# COUNTY OF ALBEMARLE STAFF REPORT SUMMARY

| Project Name: ZMA201600023 Brown Toyota  | Staff: J.T. Newberry, Senior Planner   |
| Acreage: 8.04 acres TMP: 07800000001400, 078000000014E0  | Request: remove 0.05 acres of Managed slopes and approximately 0.20 acres of Preserved slopes from the Steep Slope Overlay District and establish a new area of approximately 0.25 acres of Managed slopes   |

Figure 1: "Existing Conditions" from SDP2002-00026 (unapproved)

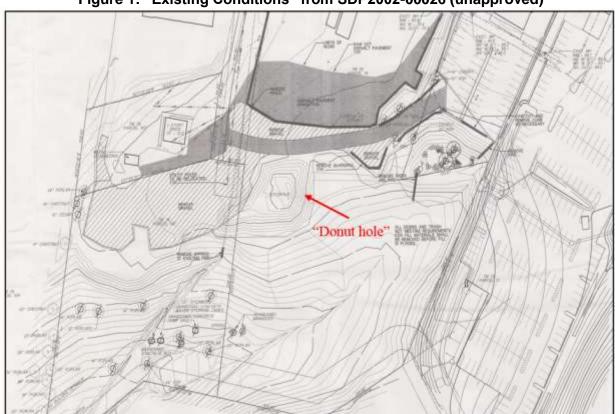
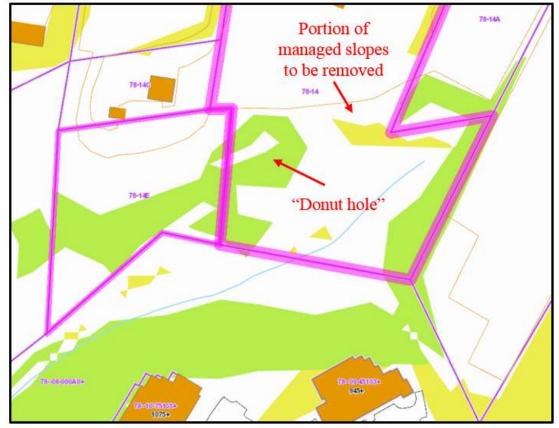
However, site visits, research on previous site plans, and the review of other maps corroborated information provided by the applicant that this portion of the preserved slopes was actually a soil stockpile. Figure 1 is from the withdrawn major site plan amendment, which labeled the stockpile on an "Existing Conditions" sheet. A comparison on the next page of the unapproved site plan amendment to the adopted overlay district map shows how the flattened top of the stockpile created the same "donut hole" in the area designated as preserved slopes. The adopted overlay district map is shown in Figure 2.

Previous site plans showed the area of the stockpile to be less than 25% slope before the accumulation of soil began. Staff is also unable to identify any benefit to reestablishing these slopes. Therefore, because the slopes in this area were both manmade and temporary in nature, staff believes they should not have been designated as preserved slopes or managed slopes with the creation of the district in 2014. Staff supports this area's removal from the Steep Slope Overlay District.
